SOUTH COAST AIR QUALITY MANAGEMENT DISTRICT ENGINEERING & COMPLIANCE DIVISION APPLICATION PROCESSING AND CALCULATIONS	PAGES 9	PAGE 1
	APPL. NO. 525368	DATE 07/26/2011
	PROCESSED BY Jon Uhl	CHECKED BY

PERMIT TO OPERATE - MODIFICATION

DeMenno/Kerdoon, Inc., SCAQMD ID # 800037
 2000 North Alameda Street
 Compton, CA 90222

Application number 525368 was received on July 8, 2011 (deemed complete July 27, 2011) for permit modifications (active permit to operate G13243, A/N 493608) to add one additional vapor return line to this vapor recovery system.

Figure 1 – Tank Venting Path

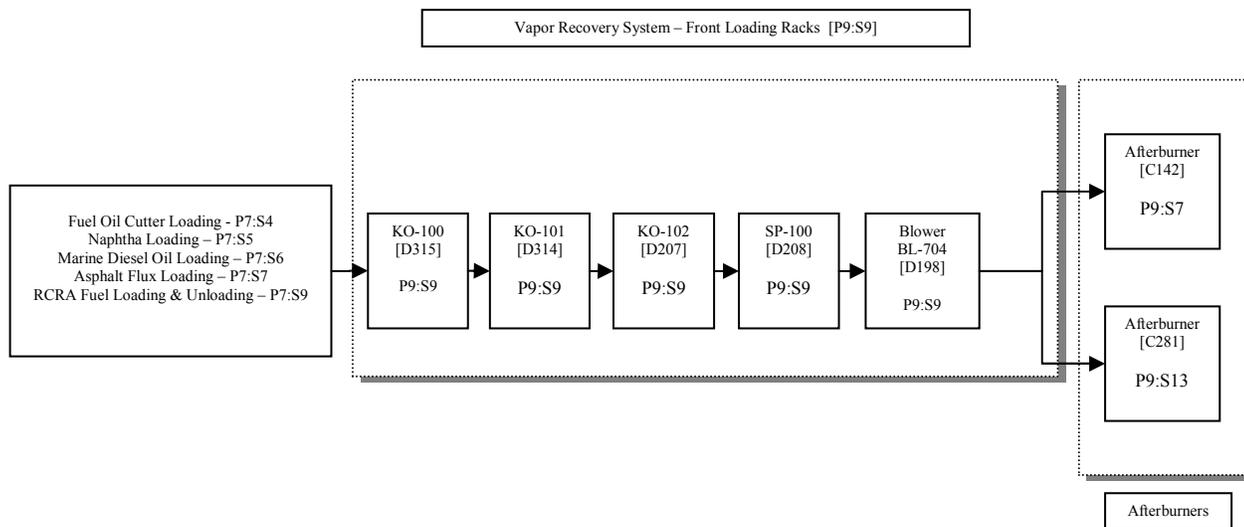
The displaced vapors are sent to the afterburners (C142 & C281) in P9:S7 & P9:S13, via knockout pots KO-100, KO-101 & KO-102, seal pot SP-400 and vacuum blower BL-704.

Process flow diagrams LR-3&4 and AB show the venting path from the loading rack to the afterburners, and are included as Attachments #1 - #2.
